Oyster Creek Generating Station
Facility Operating License No. DPR-16
NRC Docket No. 50-219

Subject: Response to NRC Request for Additional Information, dated March 30, 2006,
Related to Oyster Creek Generating Station License Renewal Application (TAC
No. MC7624)

**Response to 3/30/06 Request for Additional Information
Oyster Creek Generating Station
License Renewal Application (TAC No. MC7624)**

Fig.-1. Local Areas Affected by Rebar Corrosion (Area 1, 2, & 3)

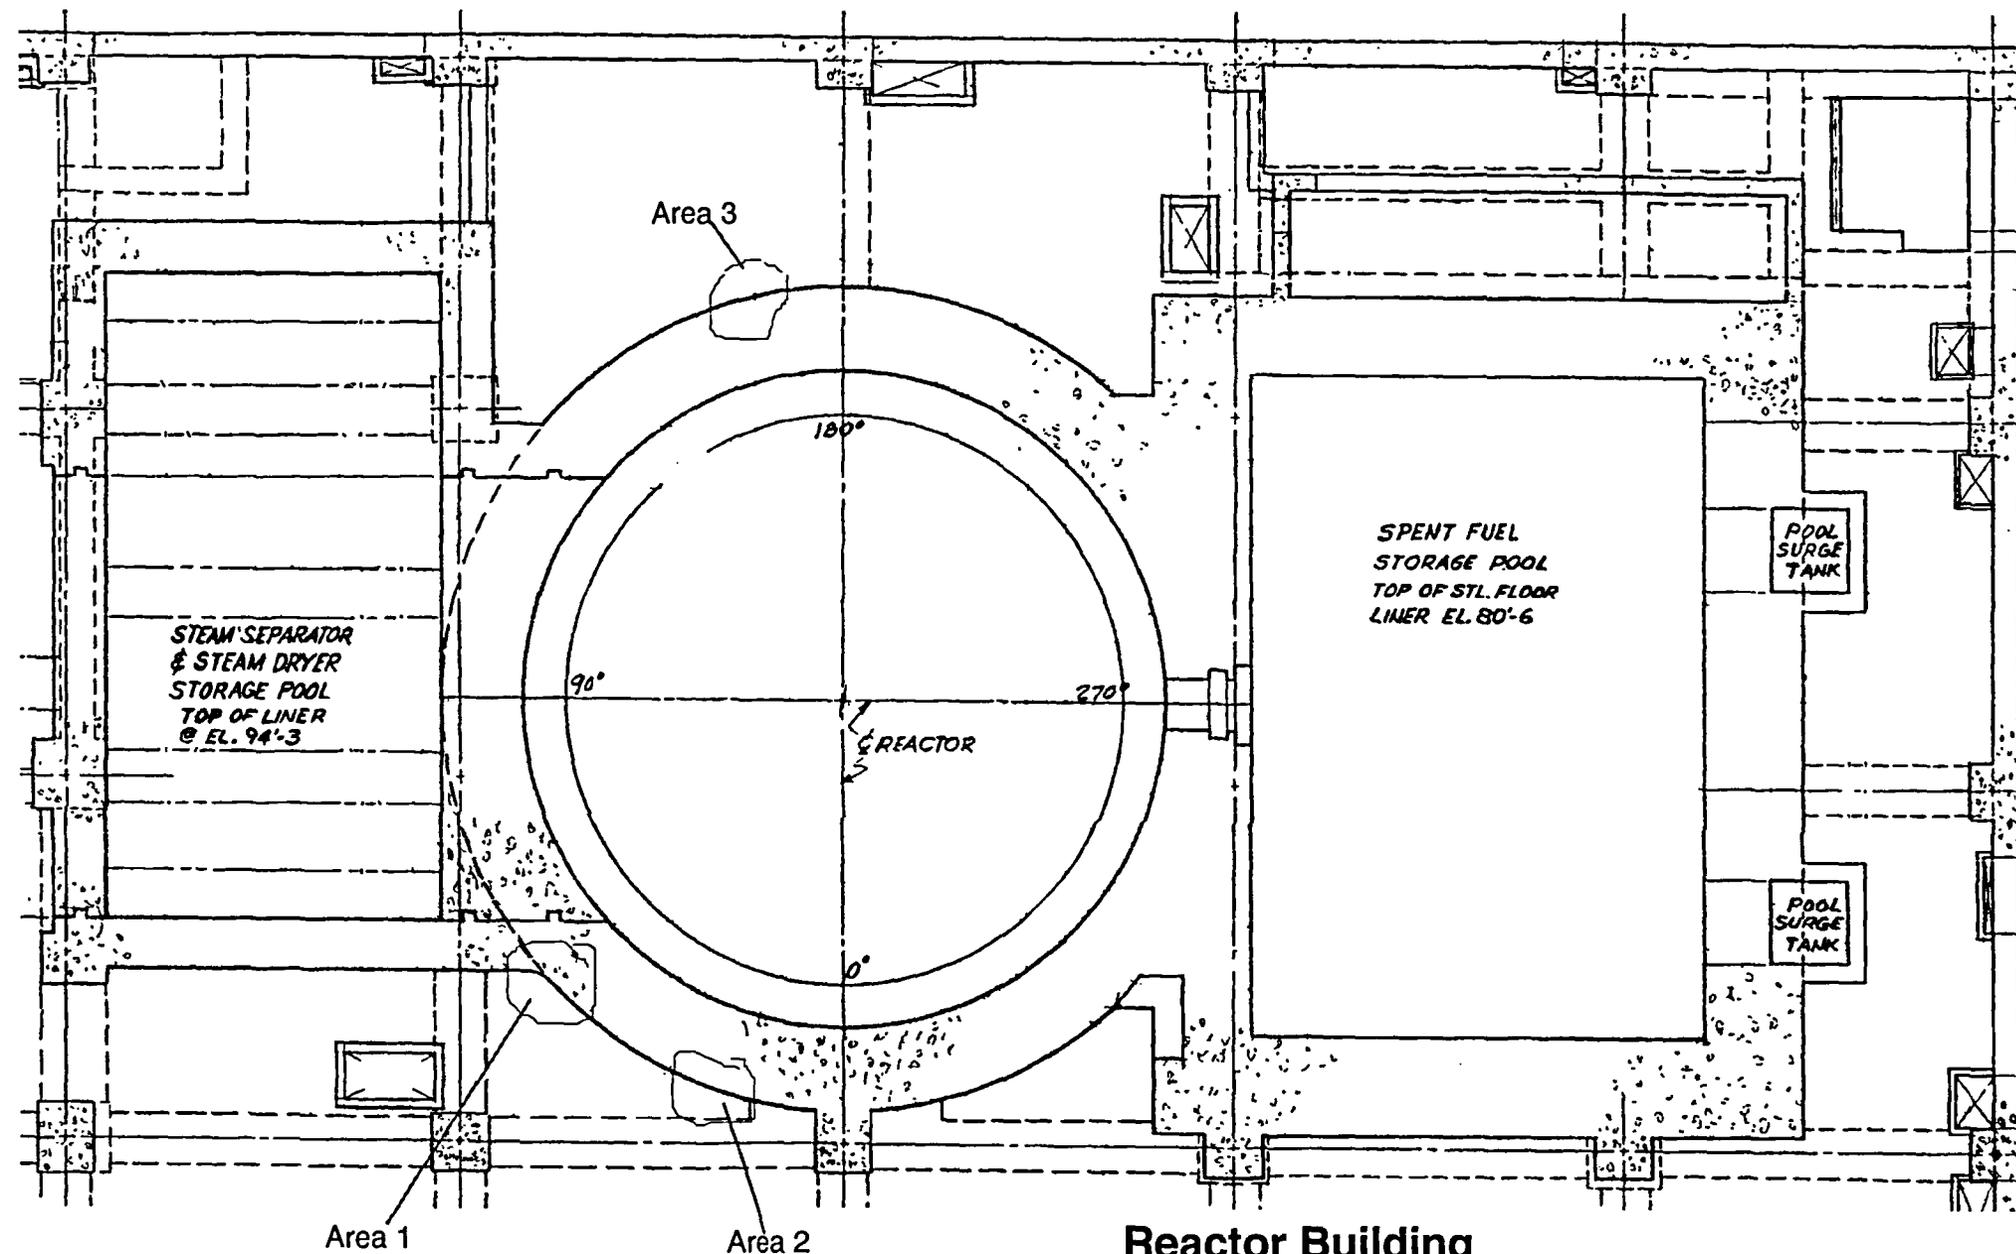
- a. An explanatory figure of the equipment pool and the reactor cavity wall areas affected by the rebar corrosion and leakages.**
- b. The extent of areas of walls affected by the corrosion and leakages.**
- c. Calculated maximum stresses in the affected rebars during (1) normal operating condition, (2) the postulated accident condition, and (3) during the postulated seismic event for which the walls are designed.**
- d. The effect of the 60-year corrosion on the stresses calculated in Item c. above.**

- a. The attached explanatory figure (Figure 1) provides a plan of the area affected by rebar corrosion and water leakage. Locations affected by corrosion and leakage are localized and noted on the figure. Water and rust stains were observed around hairline cracks on the exterior surfaces of these walls in 1986. As a result, these areas were considered suspect for rebar corrosion. The walls are also affected by the elevated temperature in the upper region of the drywell, evaluated under Integrated Plant Assessment Systematic Evaluation Report, SEP Topic III-7B.

- b. Areas of reactor cavity and equipment pool walls affected by rebar corrosion are limited to localized portions of the walls between elevation 95' and 119'. These local areas were documented in a Material Nonconformance Report MNCR #86-870 in 1986 when a reddish brown deposit (rust like) was observed in and around hairline cracks in the walls. Later, it was determined that these deposits were from iron oxide corrosion products from the embedded reinforcement steel and the corrosion was most likely a product of water leakage during refueling outages. It was considered probable that treated water entered the pre-existing cracks in the concrete wall, which wetted the surface of the rebar (Ref. 1). Based on these determinations GPU concluded that a corrosion damage assessment was necessary to establish the degree of rebar corrosion.
